# ACI Committee 376

## Concrete Structures for Refrigerated Liquefied Gas (RLG) Containment

### Agenda

## ACI 376 Gap Analysis Comments

Fig. A.4 - Examples of concrete primary container walls in a double-containment tank system

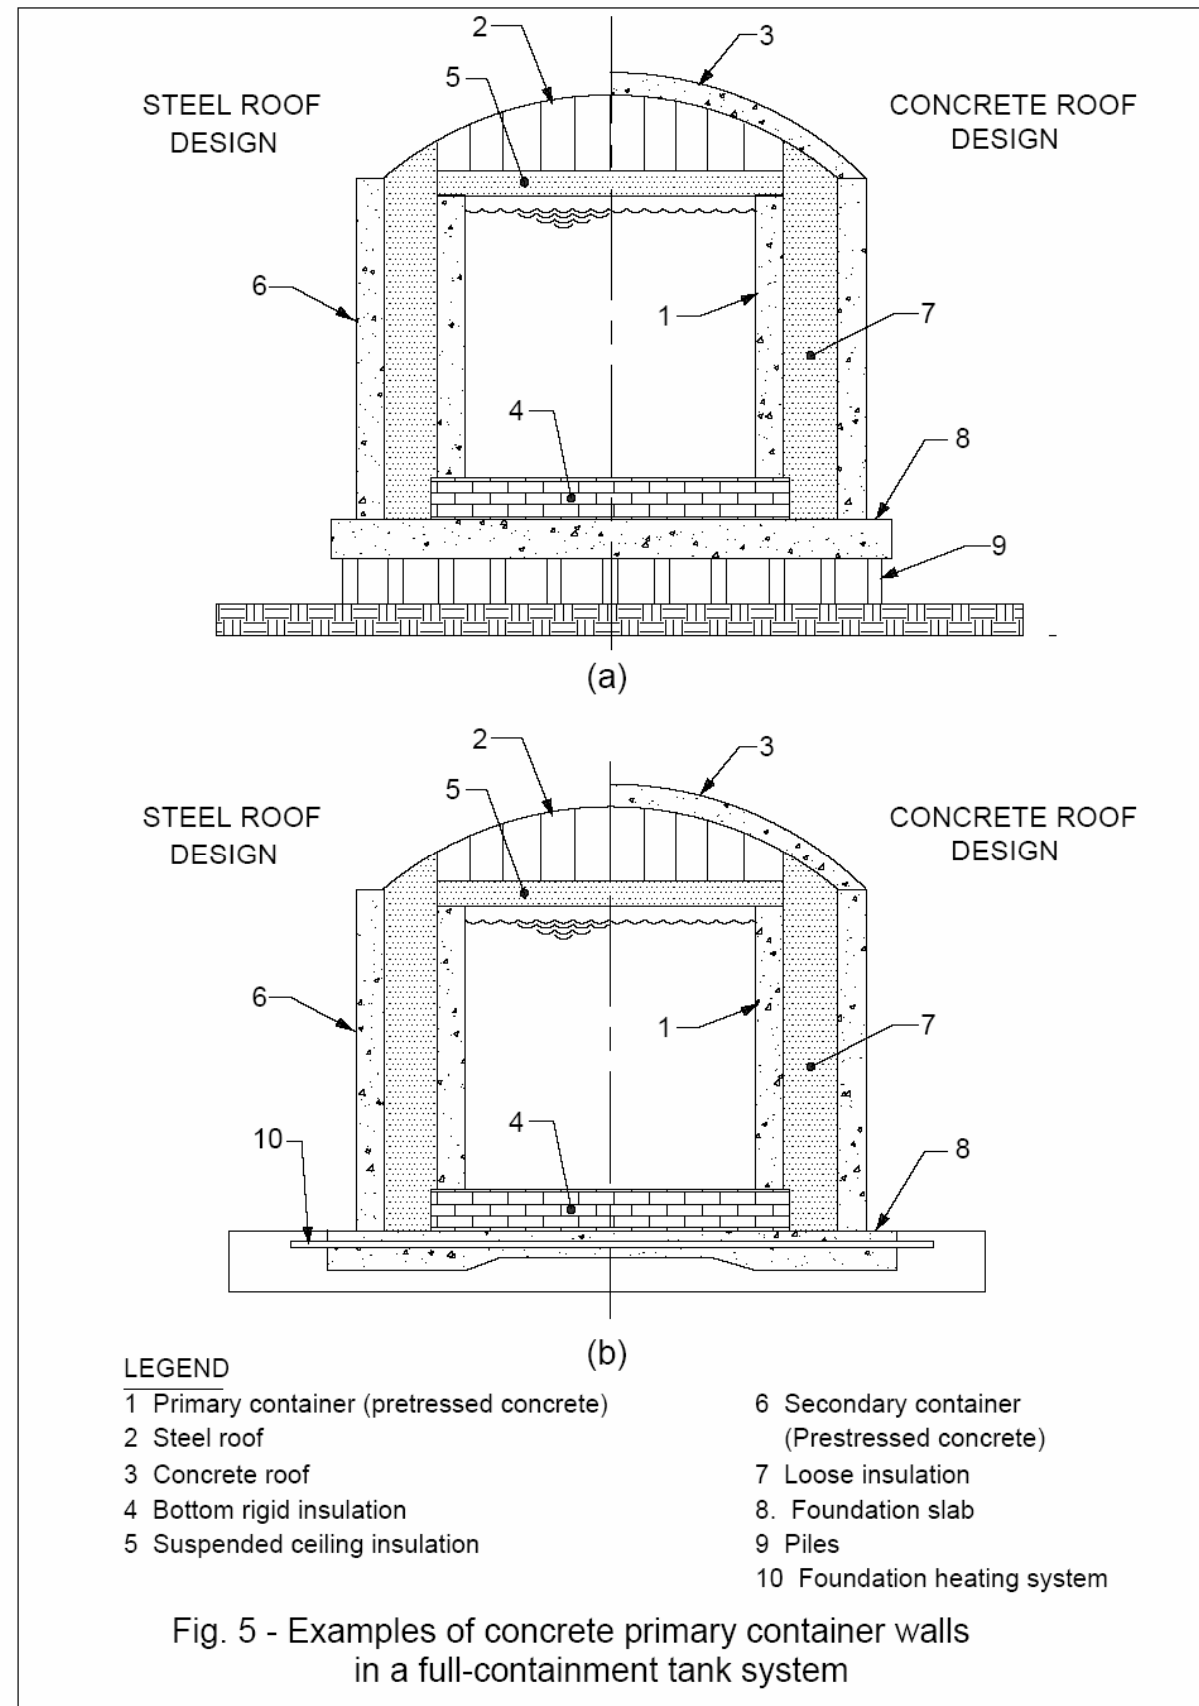
Text Balloted	Vote	Committee Members' COMMENTS	Author	RESPONSE	Notes
<p><b>APPENDIX A</b> <b>GENERAL COMMENT</b> The ballot proposes that the first negative by Hoptay is found persuasive, and that the six figures illustrating the different containment types be reintroduced in Appendix A (see the attached file).</p> <p><u>Reason:</u> There is a need for a series of figures illustrating the different containment types (single, double and full containment). Such figures were in fact included in the earlier drafts of this code and are cited in the last paragraph of Section R1.0; and they should be reintroduced in Appendix A.</p>	<p>Approved = 18 App w com = 1 Neg = 1 Abs = 3</p>	<p>Figure 6 can not be included in this standard since membrane tanks are not included in this standard. None of the chapters currently include any guidance from membrane tanks.</p>	Hoptay, Joseph	<p>Remove Fig 6 and update drawings</p>

<p>Agree with proposed change for Hoptay - Part 1, but think we should have these undated and redrawn in a format consistent with other graphics in Appendix A.</p>	Pawski, Rolf		
<p><b>APPENDIX A</b> <b>GENERAL COMMENT</b> The ballot proposes that the second negative by Hoptay is found not persuasive and that no changes be made in response to Part 2 of Hoptay's negative.</p> <p><u>Reason:</u> The details suggested by this comment (combining primary and secondary containers with cast-in-place and panel construction) do not lend themselves to unique, exclusive solutions. Instead, the designer should be allowed some latitude in developing these details to suit the needs of a particular project – as long as they satisfy the prescribed performance criteria.</p>	<p>Approved = 19 App w com = 1 Neg = 0 Abs = 3</p>	<p>While it is recognized that the designer should have latitude to develop details that meet a particular project need, the minimum performance criteria, design and analysis and details all need to recognize all possible design concepts that are currently envisioned and provide guidance for those concepts</p>	Hoptay
